March 15, 1991
LD-91-013

Project No. 675

Subject: Response to NRC Requests for Additional
Information

Reference: NRC Letter, Request for Additional Information,
T. J. Kenyon (NRC) to A. E. Scherer (C-E), dated
June 26, 1989

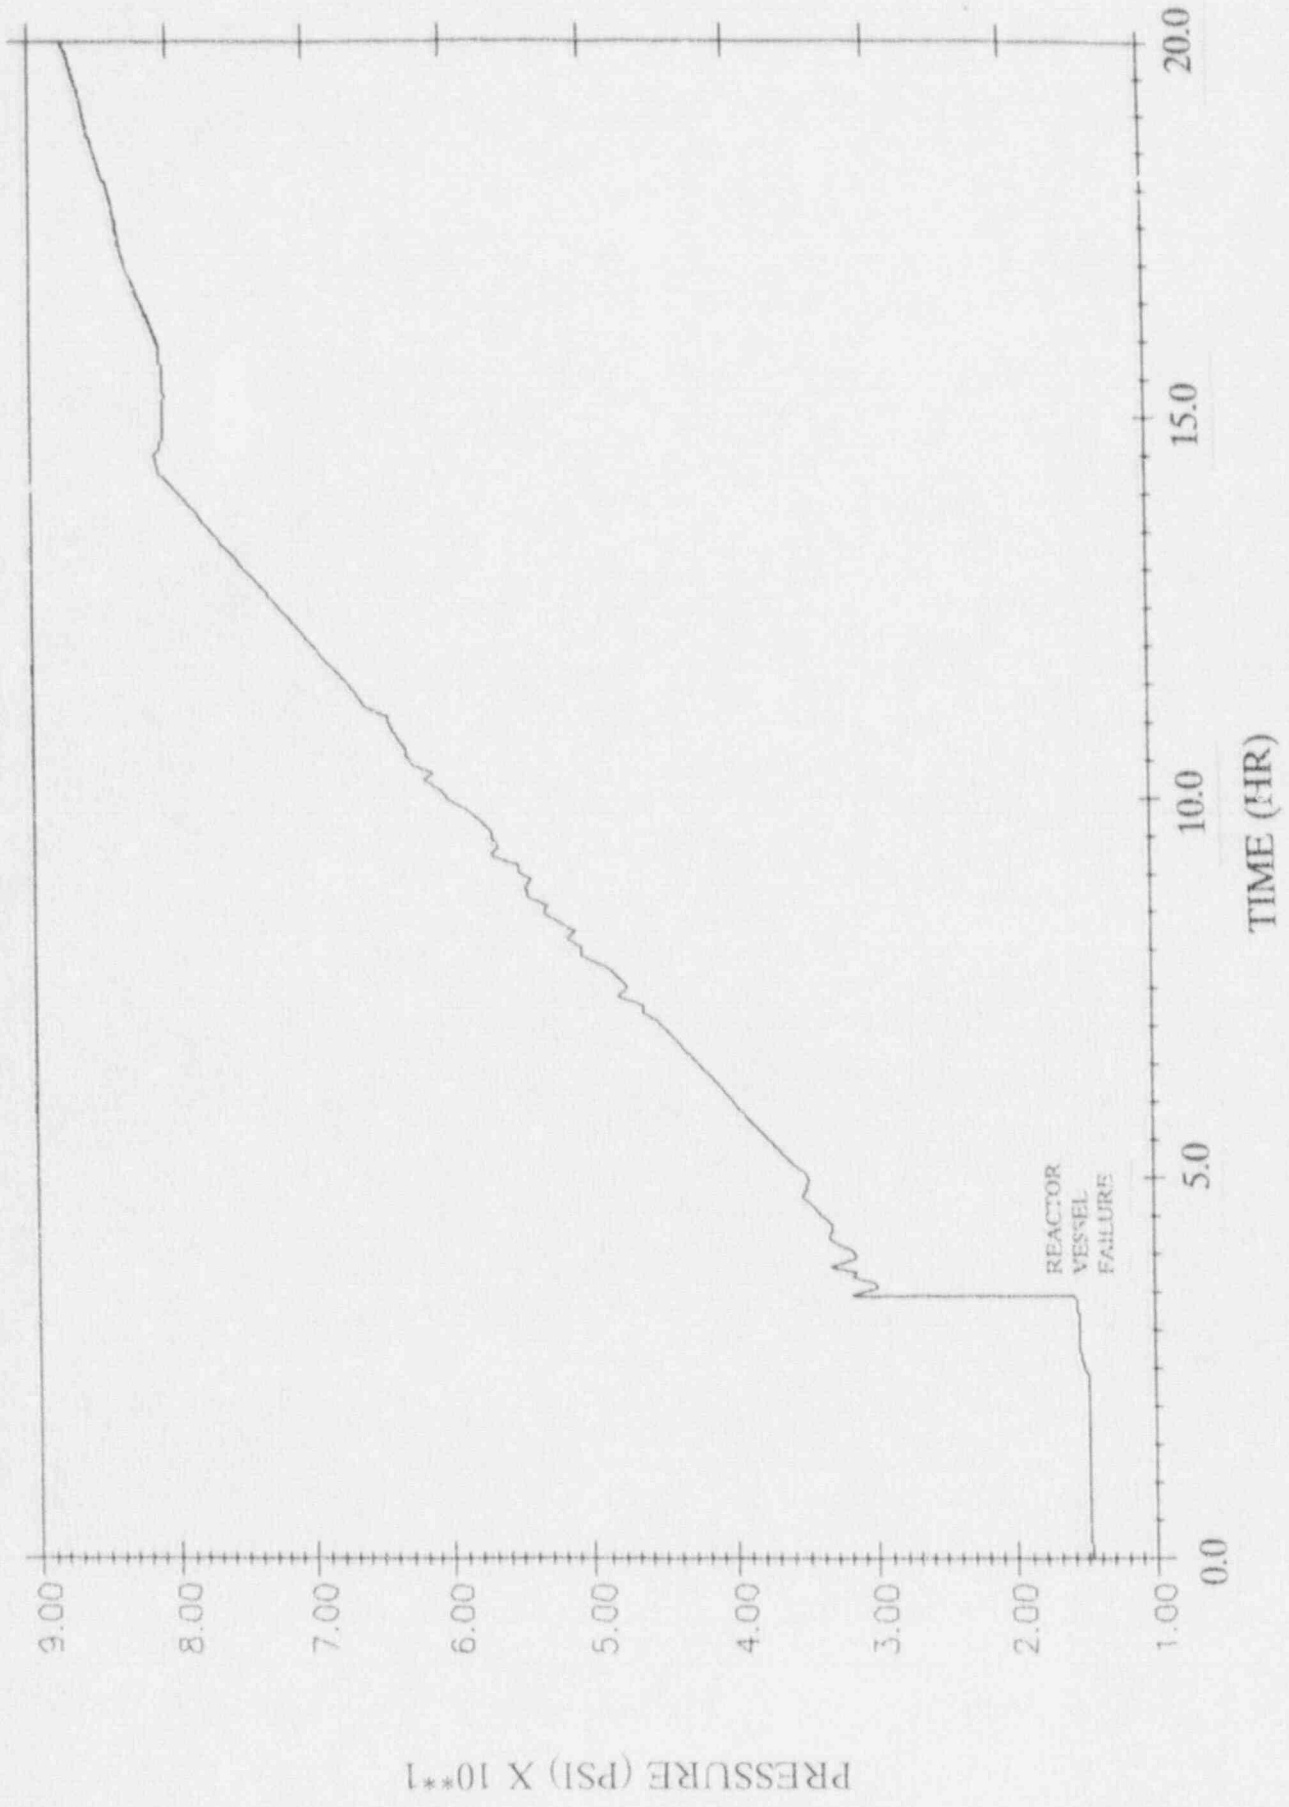
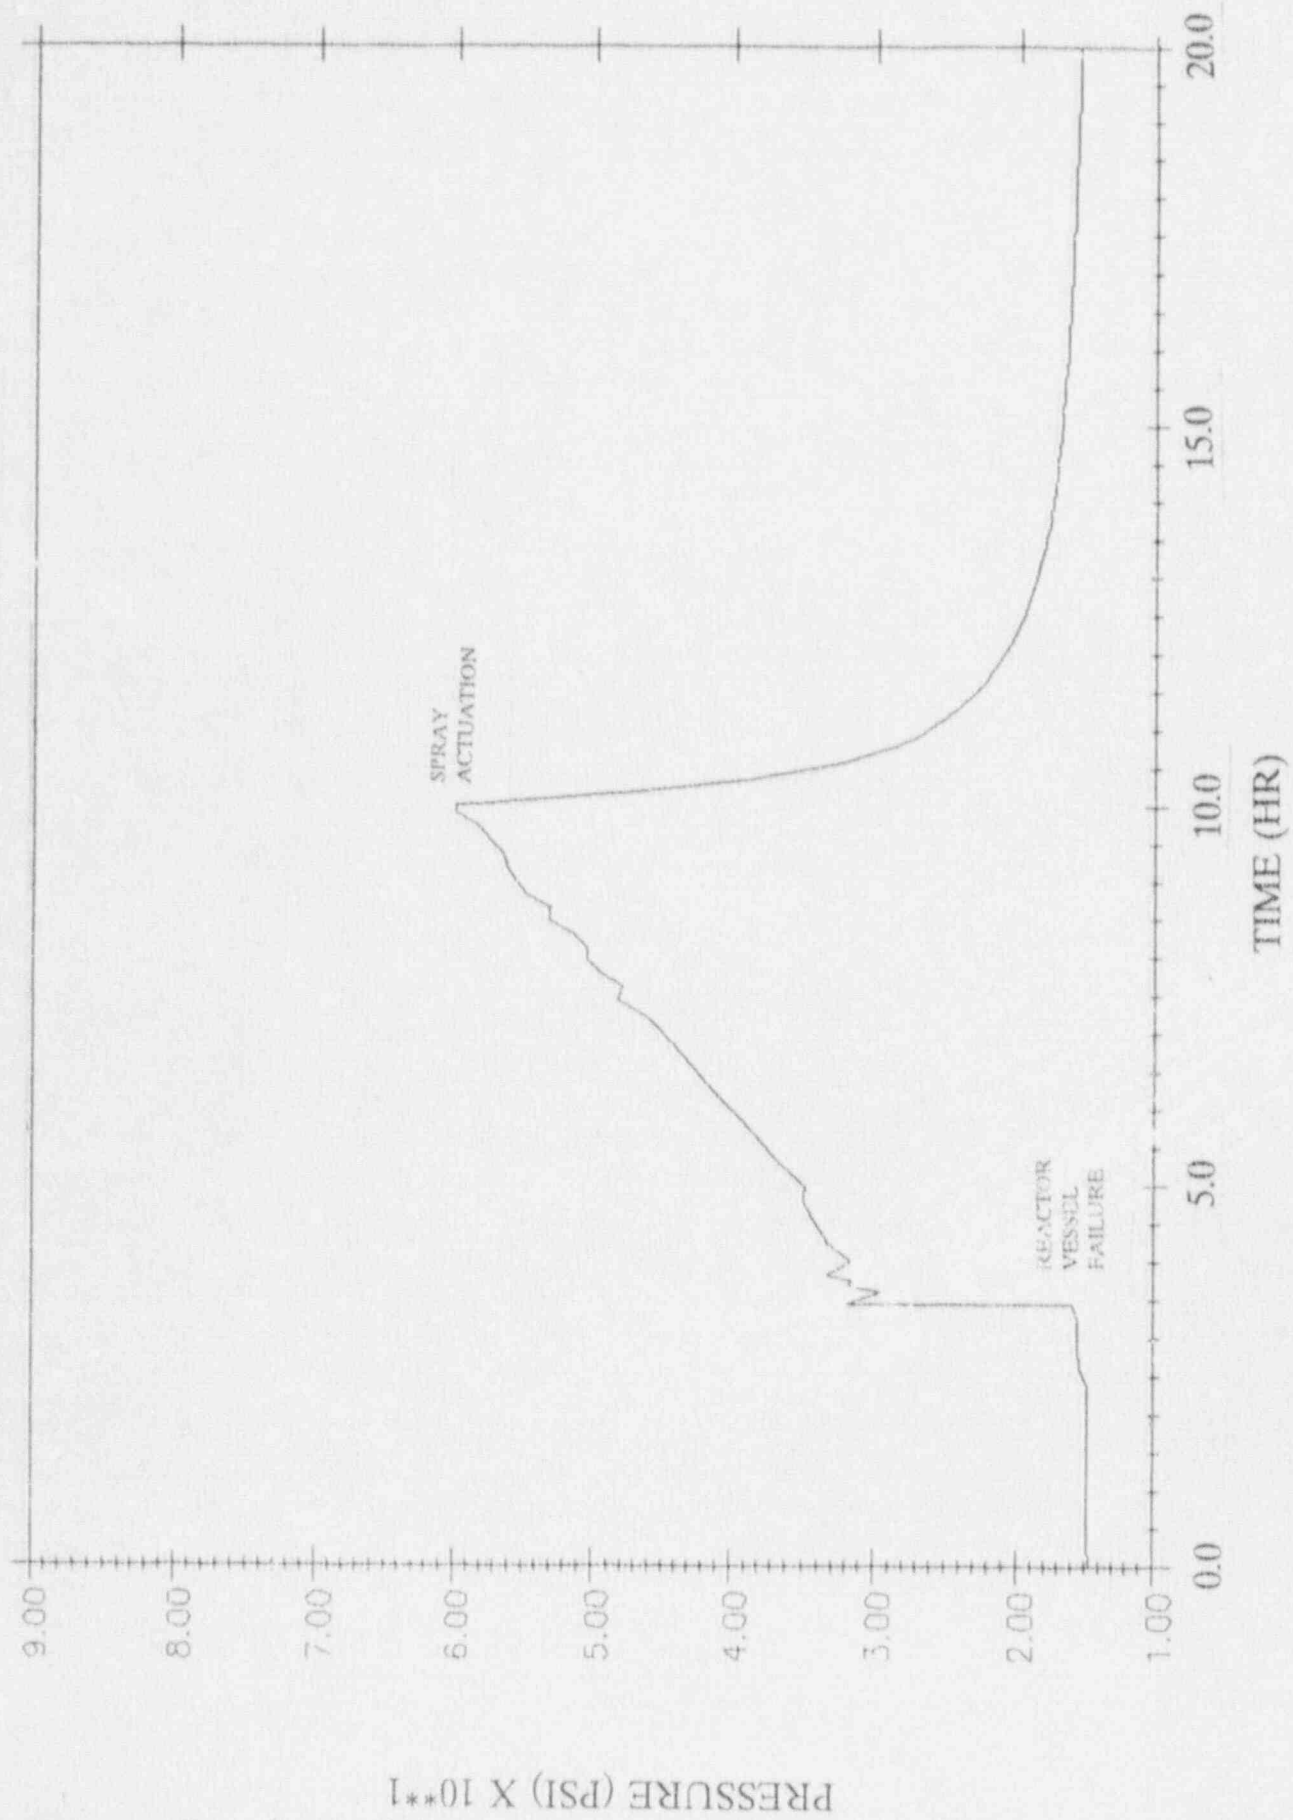
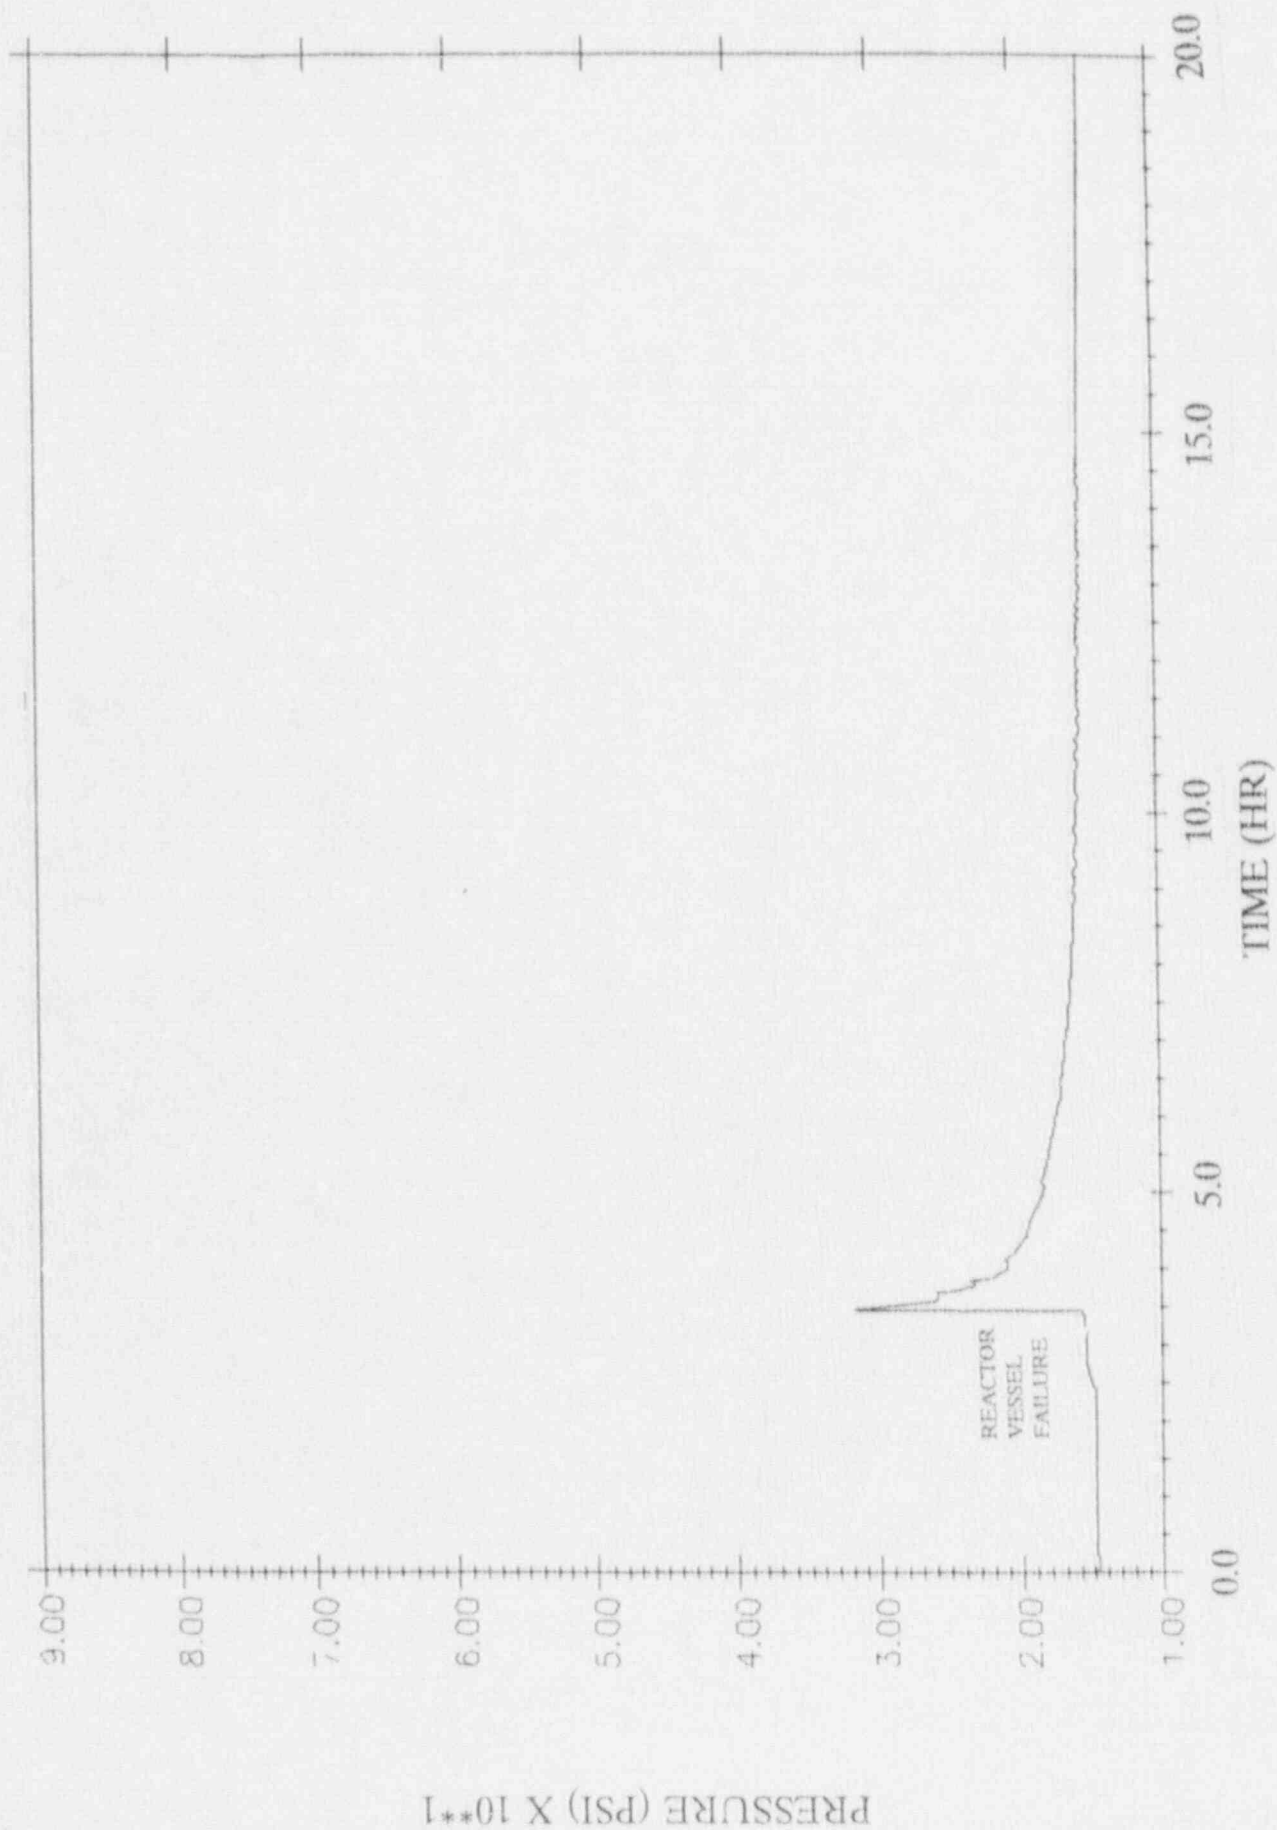
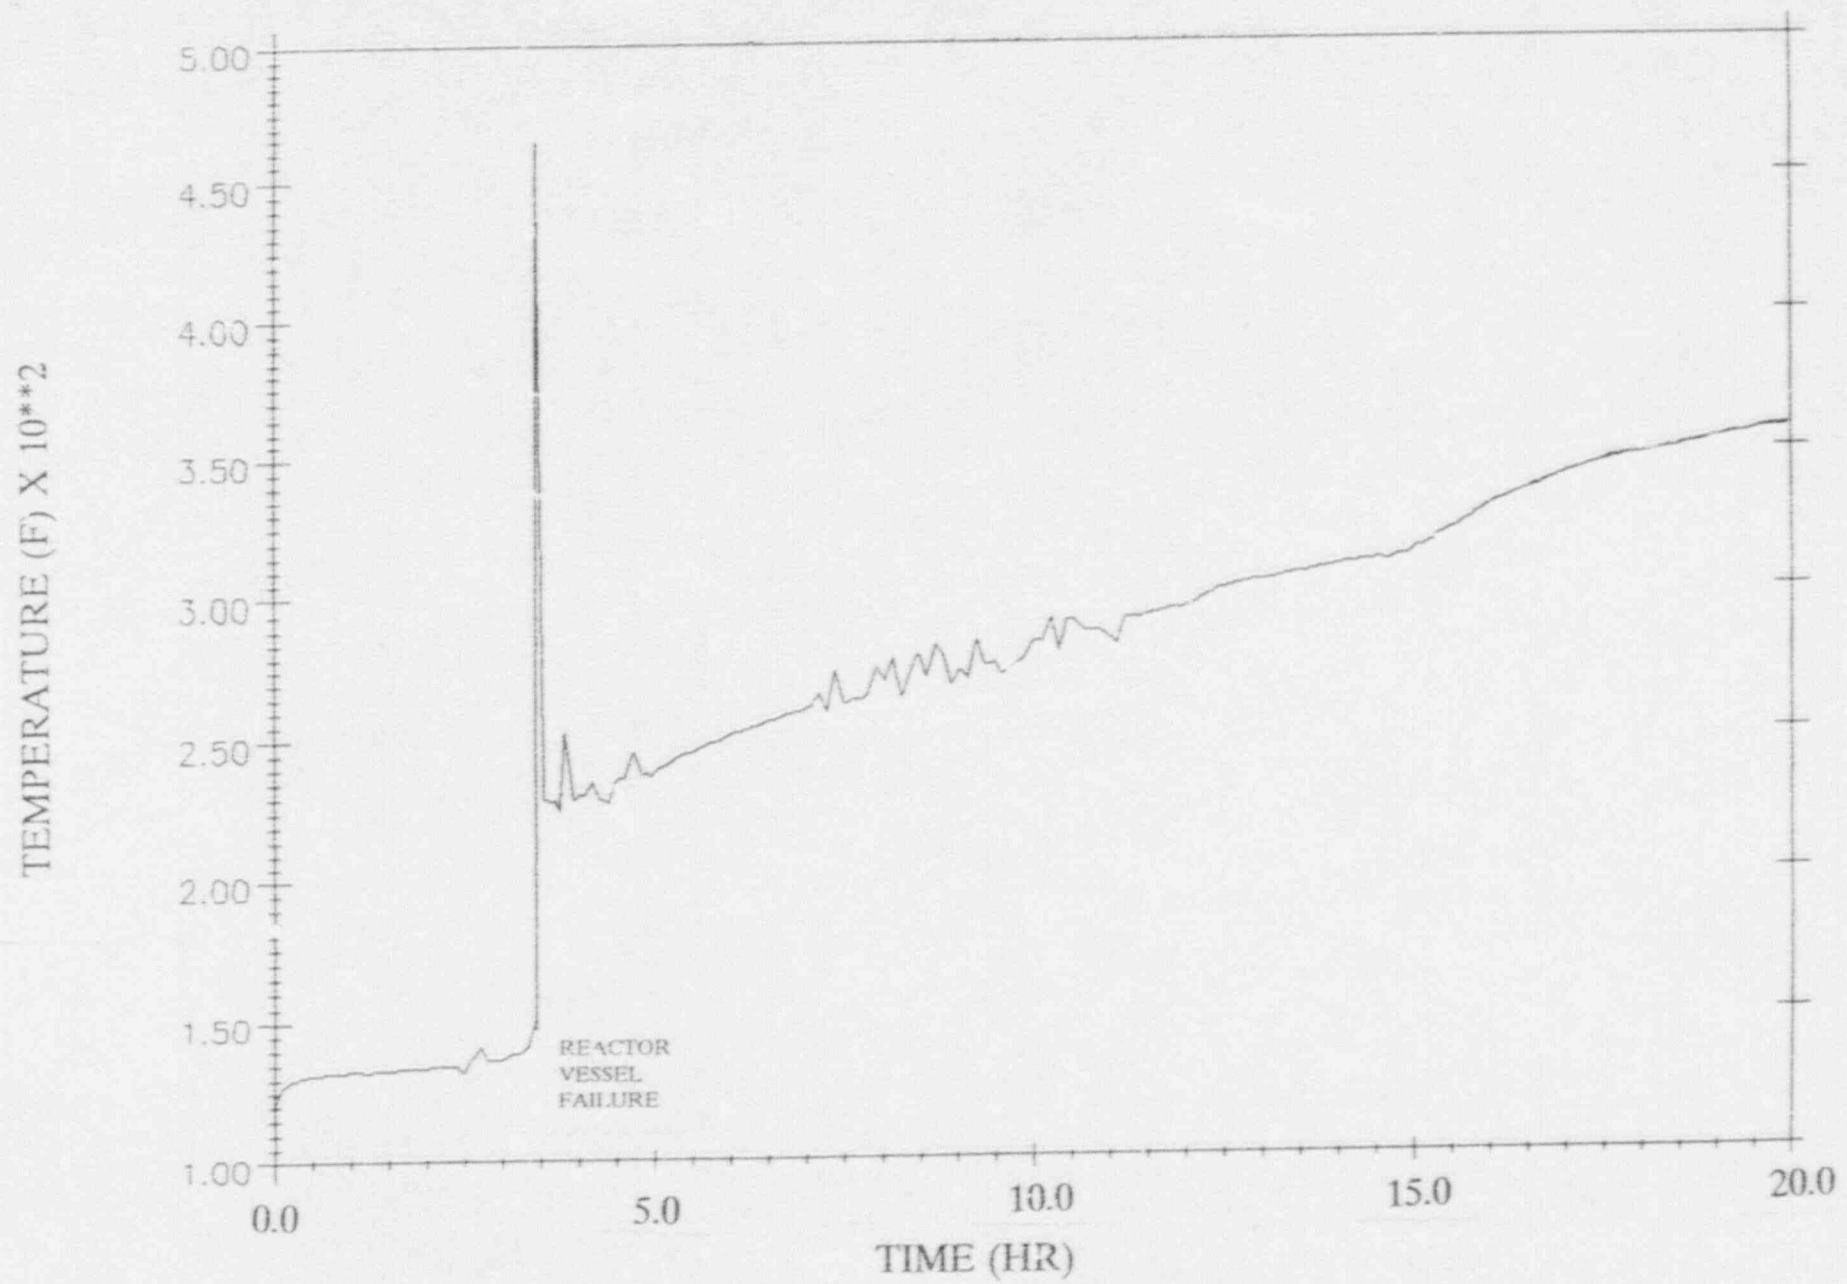
Provide a technical analysis and evaluation of the containment spray system's effectiveness in reducing containment pressure and temperature and lowering radioisotope releases during postulated dominant severe accident sequences. Discuss specific system design features for enhancing the mitigation of severe accident consequences.

An evaluation of the containment spray system is provided in Section 6.5.3 of Amendment I to CESSAR-DC. This section references Section 15.6.5 and Appendix 15A for a discussion of the effectiveness of removing elemental iodine from the containment atmosphere. The MAAP computer code is used for analysis of severe accident scenarios. The attached figures show the effect of the containment spray system in reducing the containment temperature and pressure for a severe accident. The severe accident analyzed is Station Blackout (SBO) and cases of normal spray initiation, delayed initiation, and no sprays are presented.

Design features which enhance the mitigation of severe accident consequences are described in Section 6.5. The safety-grade classification of the Containment Spray System (CSS) provides reasonable assurance that its mitigative function will be accomplished in severe accident environments similar to those predicted by MAAP. Comparison of the containment pressure and temperature for design basis events in Section 6.2.1 of CESSAR-DC to those for the attached case with "early" (normal) spray initiation indicates similar results for design basis and severe accidents. Please note, however, that the design of the CSS results from the design bases listed in Section 6.5, not from specific MAAP analyses.
